SUBJECT: NEW ORCHARD FARM ELEMENTARY SCHOOL  
ORCHARD FARM R-V SCHOOL DISTRICT  
ST. CHARLES, MISSOURI  
PROJECT # 23-09B

Enclosed please find one (1) electronic .pdf copy of Addendum No. 2, dated August 1, 2024, for the above-named project.

ORCHARD FARM R-V SCHOOL DISTRICT  
NEW ELEMENTARY SCHOOL  
ST. CHARLES, MISSOURI

FP2.3  
SD: 72

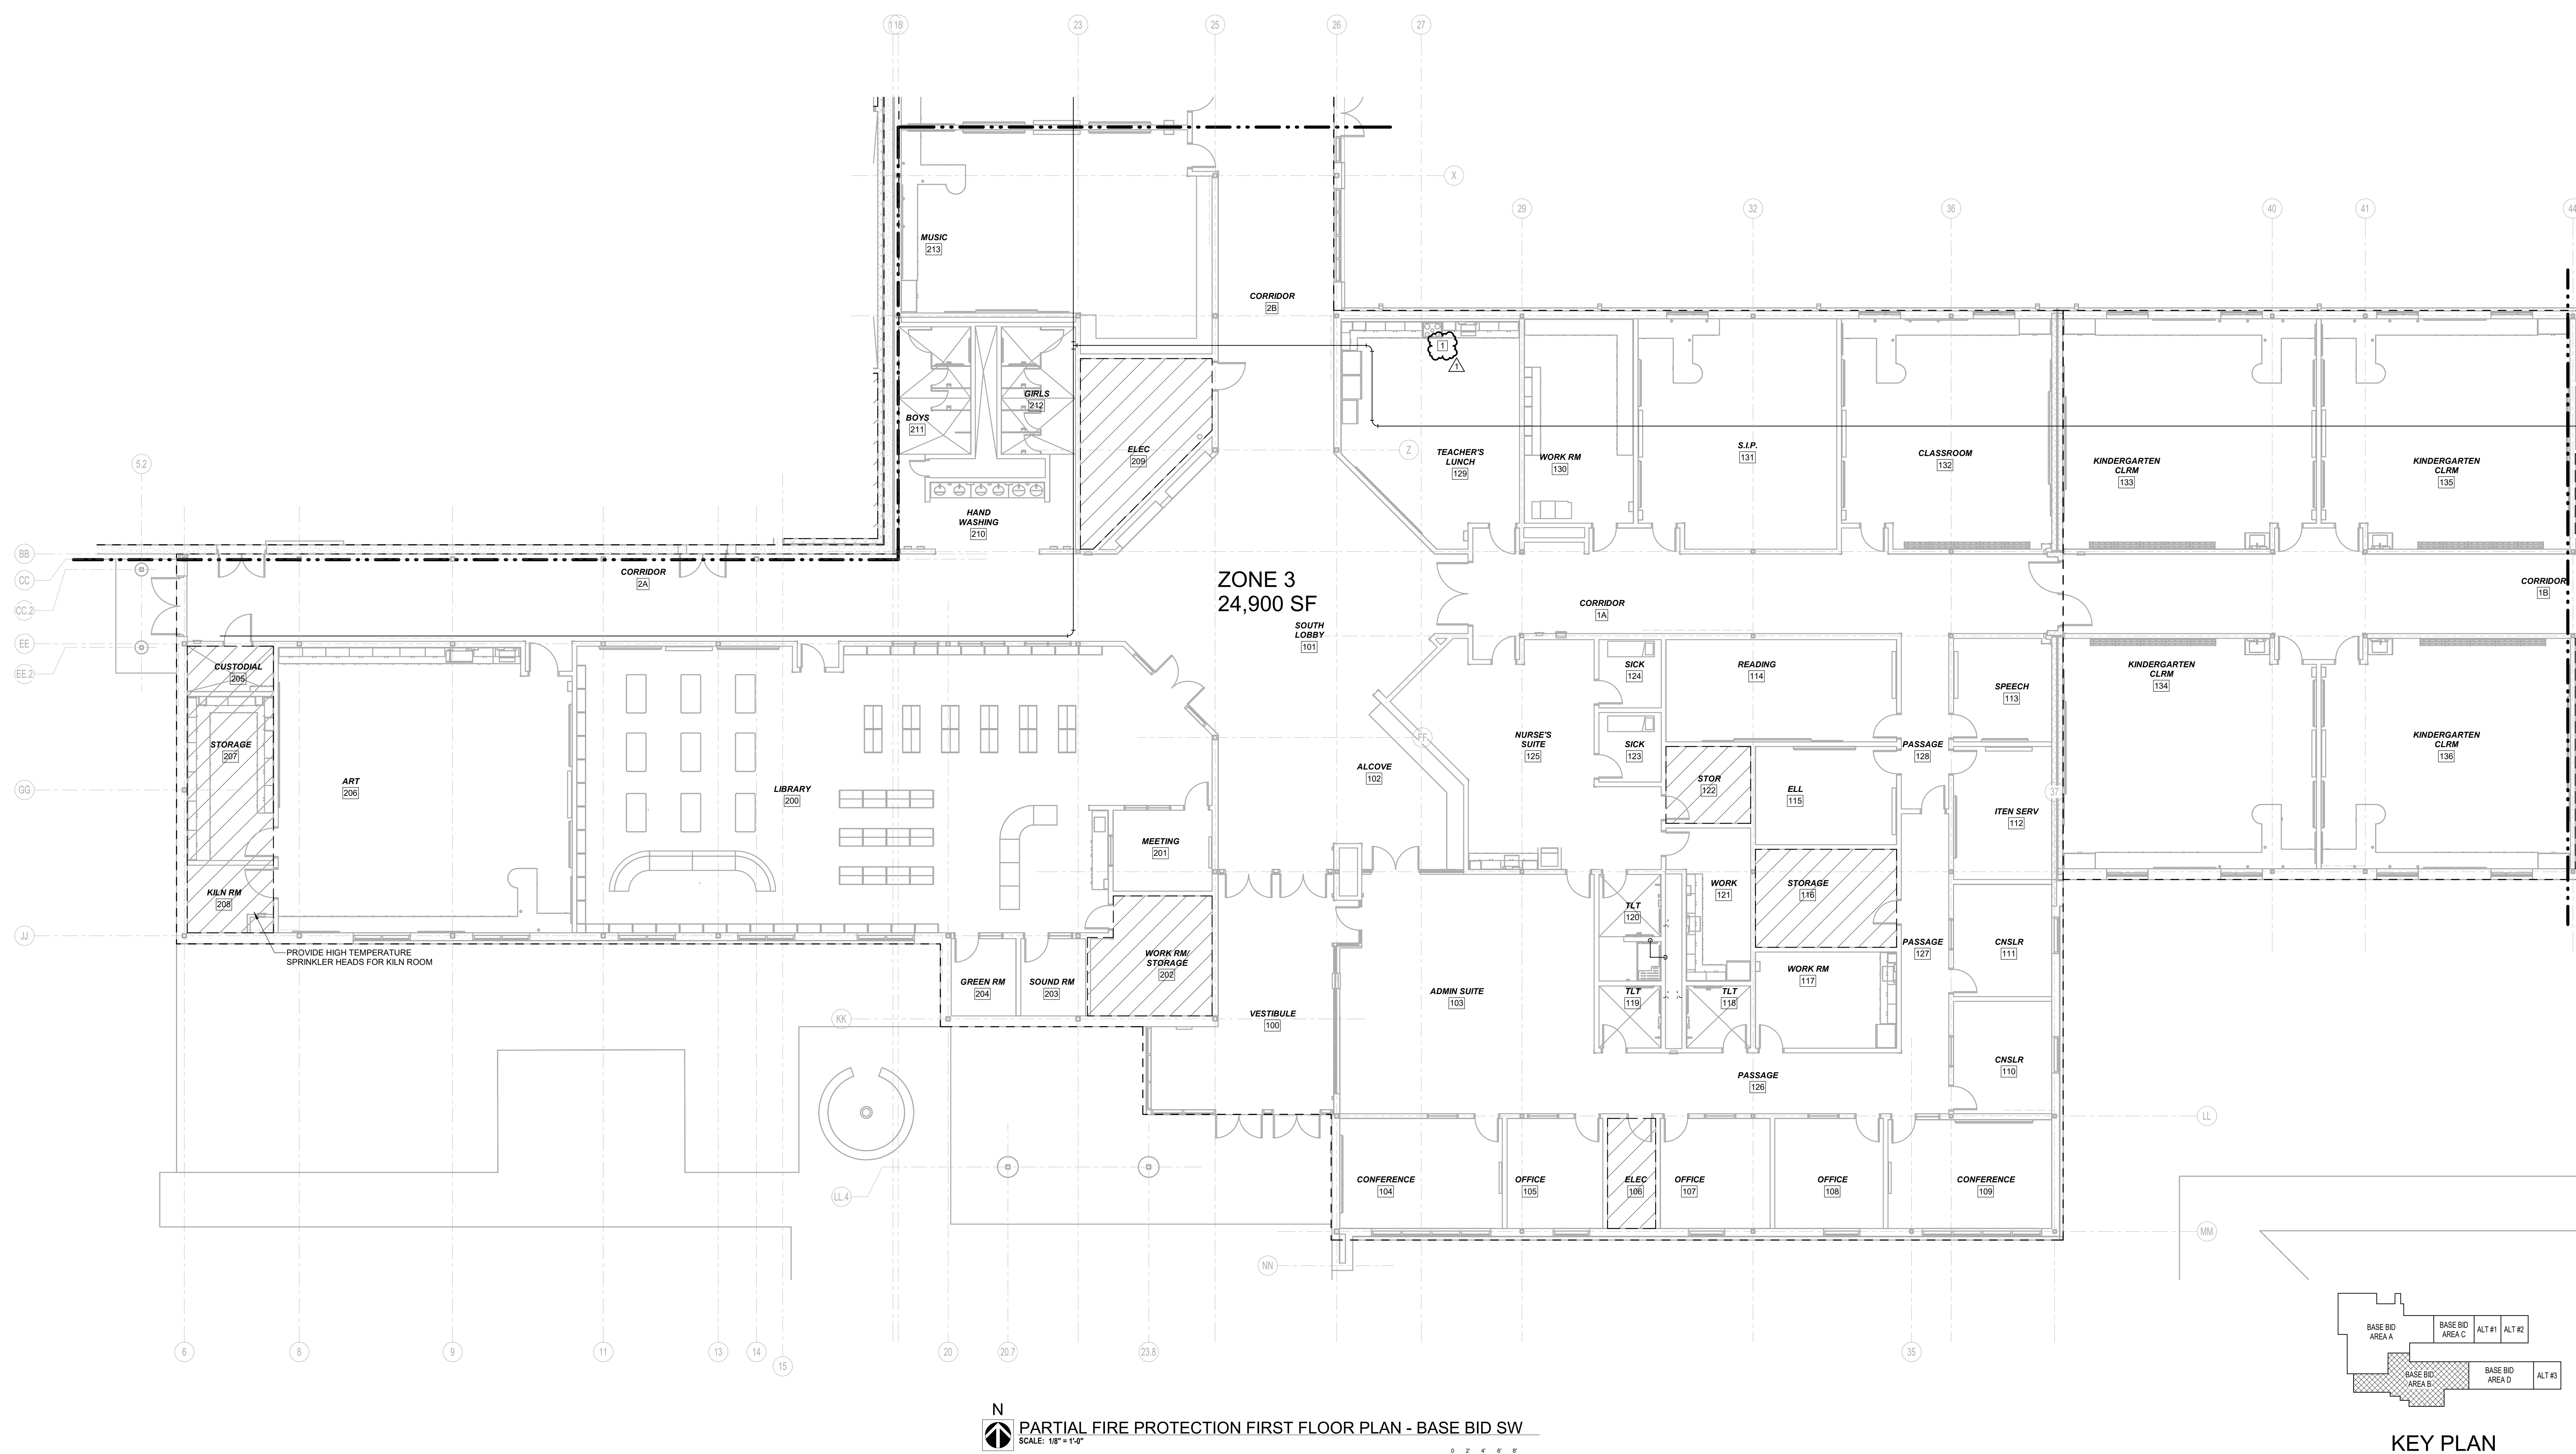
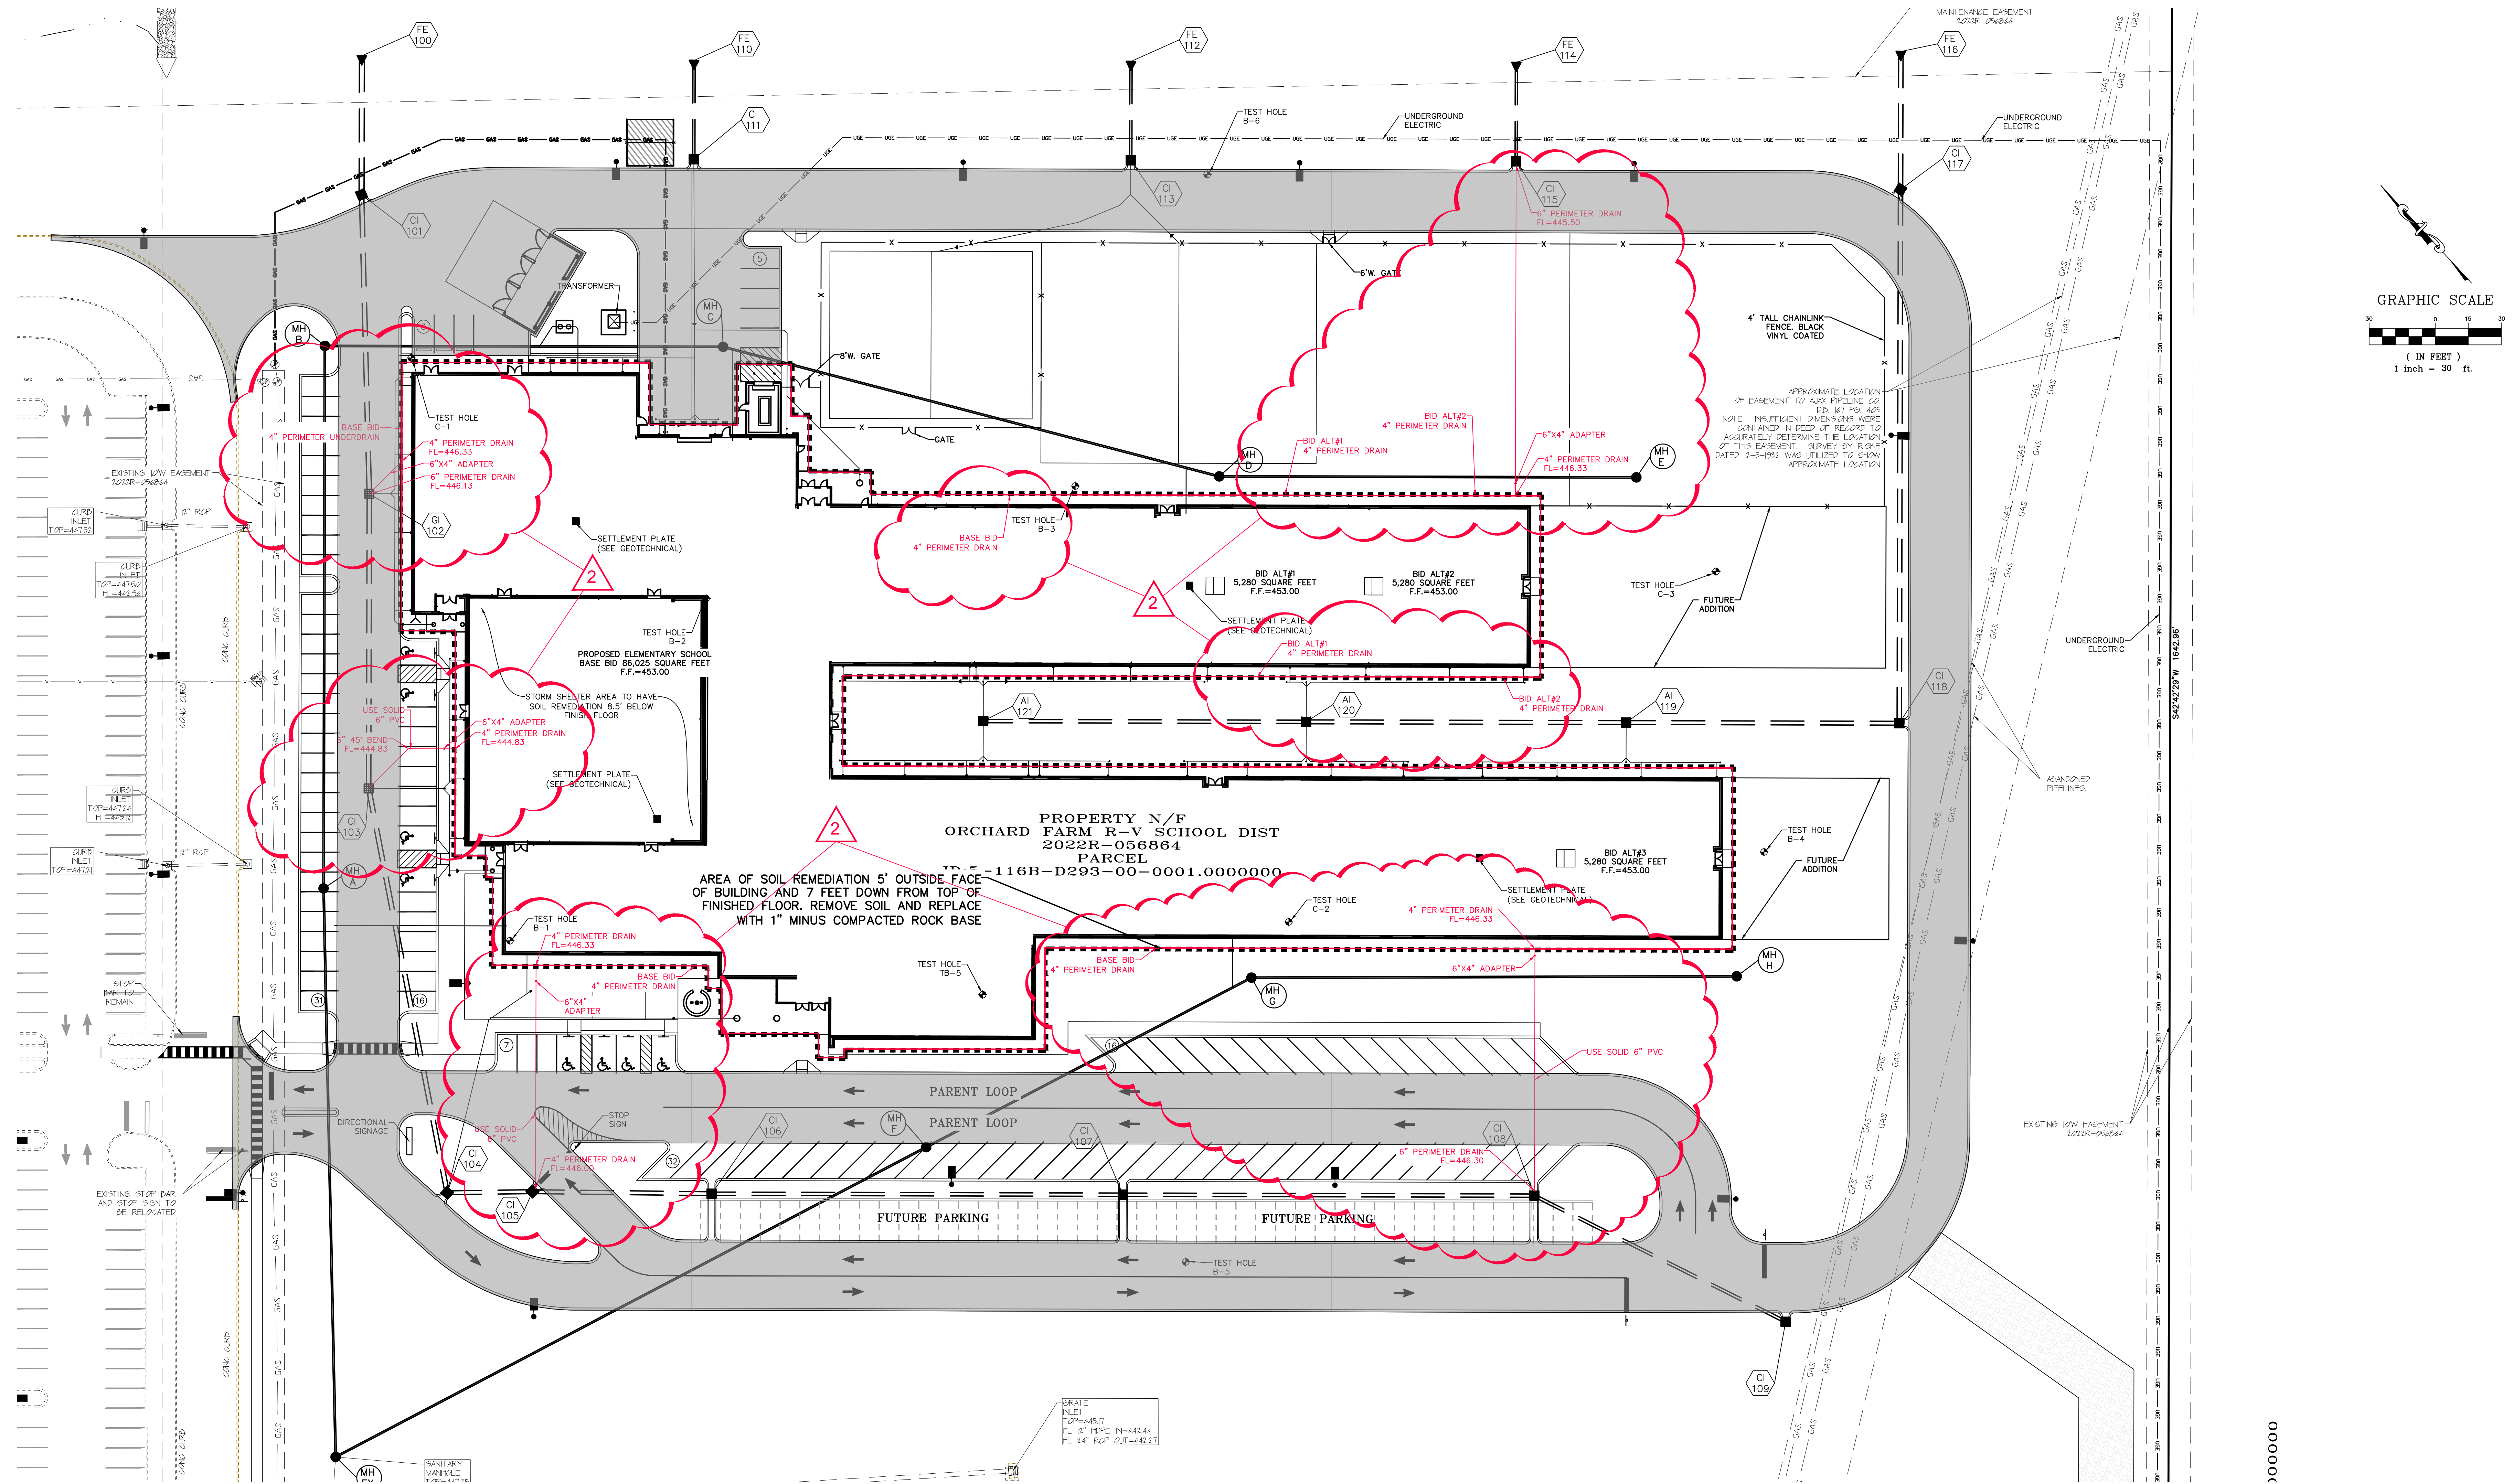
ITEM NO. 56 – MECHANICAL DRAWING SHEET FP2.3

- A. **“ADD”** Fire protection piping connection to kitchen hood.

C3.20  
SD-74

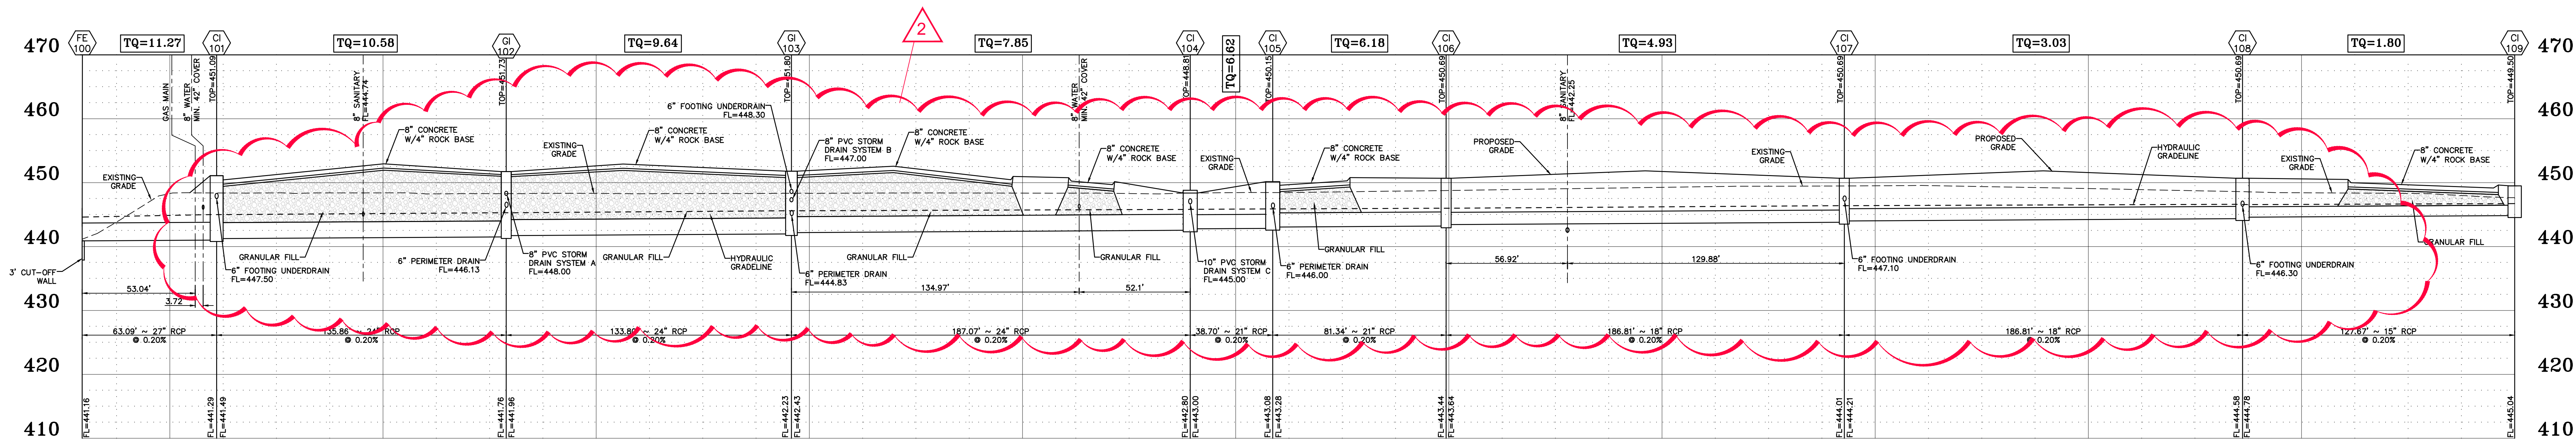
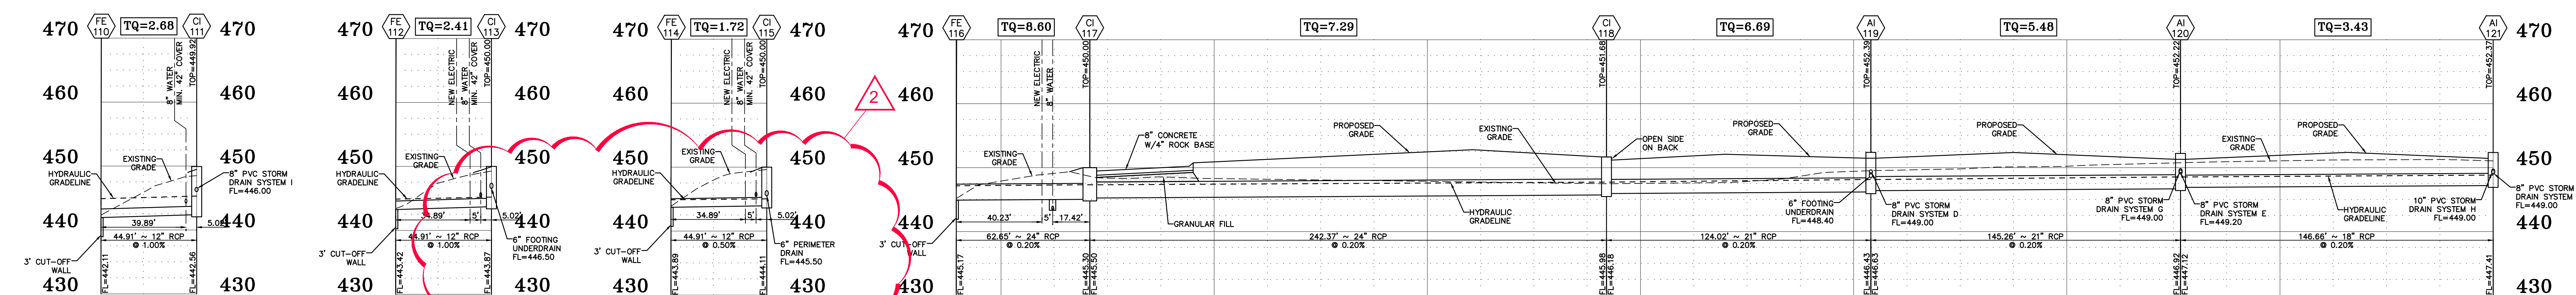
ITEM NO. 6: CIVIL DRAWING C3.20

- A. **“ADD”** Supplementary Drawing No. SD 74, dated August 1, 2024 included with this Addendum, and hereby made a part of the Contract Documents that shows the Sub-Soil Drain renamed to Footing Underdrain and added Downspout Table J.
